UNITED STATES PATENT AND TRADEMARK OFFICE

APPLICATION NO.	FILING DATE	FIRST NAMED INVENTOR	ATTORNEY DOCKET NO.	CONFIRMATION NO.
09/923,720	08/06/2001	Frank Pietzschmann	2000P15141	1125

**Office Action Summary**

**DETAILED ACTION**

FIG. 1

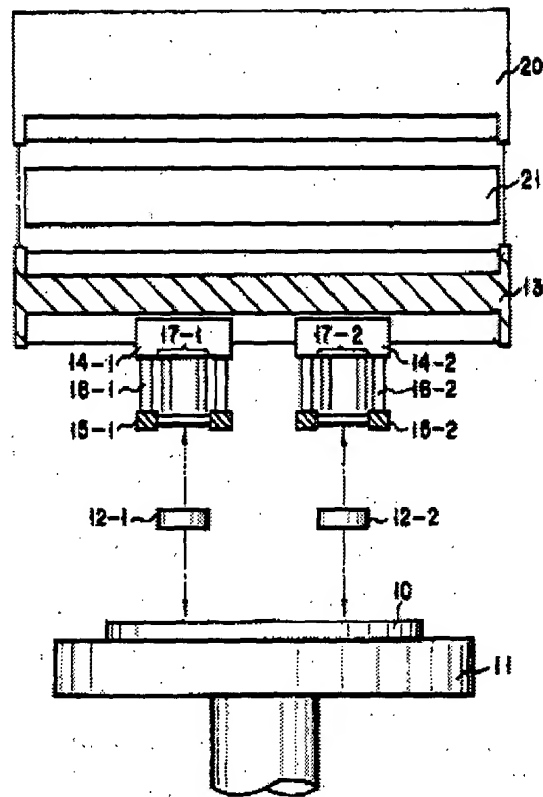
Momohara ('912) disclose probing equipment and expressly teach to include a plurality of partial cards that are separated from each other (see Fig. 1 below).

It would have been obvious to one of ordinary skill in the art at the time the invention was made to incorporate the teaching of Momohara ('912) 's plurality of partial cards into Hagihara ('192) 'probe card in view of Itoyama ('053) for the purpose of having a high processing ability at a low price disclosed by Momohara ('912) (see Col. 1, lins 66-67).

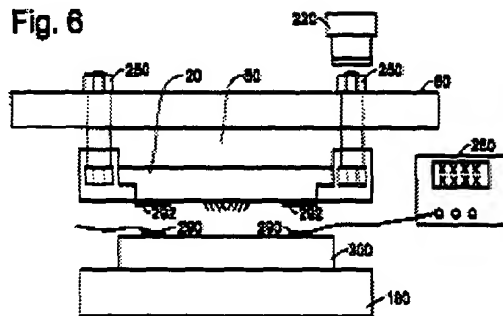
Hagihara '(192) in view of Itoyama ('053) do not teach that their probe card has a device for storing and outputting an identification number.

Nagasawa ('083) teaches a probe apparatus and expressly teach a probe card (21) has a device (ROMs 48) for storing and outputting an identification number (the serial number of a probe card).

It would have been obvious to one of ordinary skill in the art at the time the invention was made to incorporated the teaching of Nagasawa ('083)'s device for storing and outputting an identification number and for applying coordinated signals to the wafer into Hagihara '(192) 'probe card in view of Itoyama ('053) for the purpose of avoiding collision between the probe card and semiconductor disclosed by Nagasawa ('083)(see abstract).
